From: Joan Frederiksen
To: [Ballew, Cassie](#)
Subject: LU 17- 144195 DZ -appeal testimony
Date: Thursday, February 15, 2018 12:53:12 PM
Attachments: [attachment 1.pdf](#)

The following requested conditions of approval or changes (supported by the narrative below) are needed to meet the 33.284.050.A-D approval criteria or the development standards of 33.410 that impact the design of the building:

SOUTH

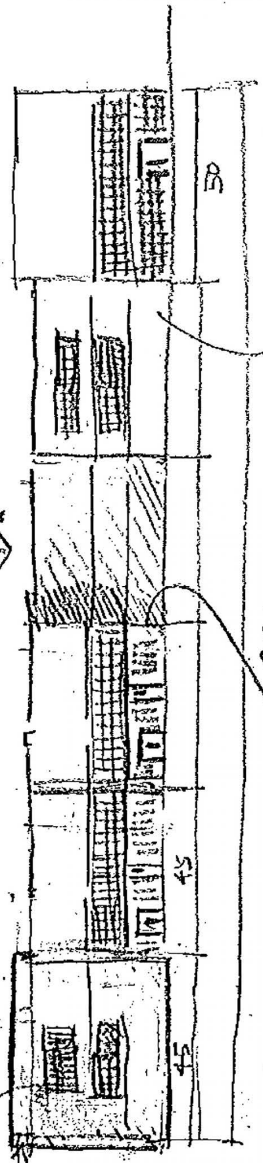
So meeting like this?

abstract mural!

recessed 15' (more towards center & impact on feeling of mass)

taller parapet to match other corner?

more balanced glazing and entrances

27'4" put windows around this corner

WEST

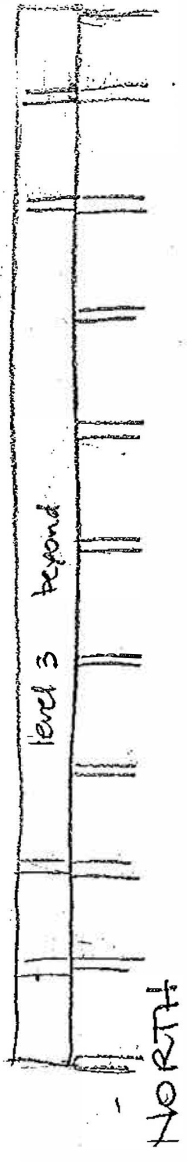
STEP DOWN
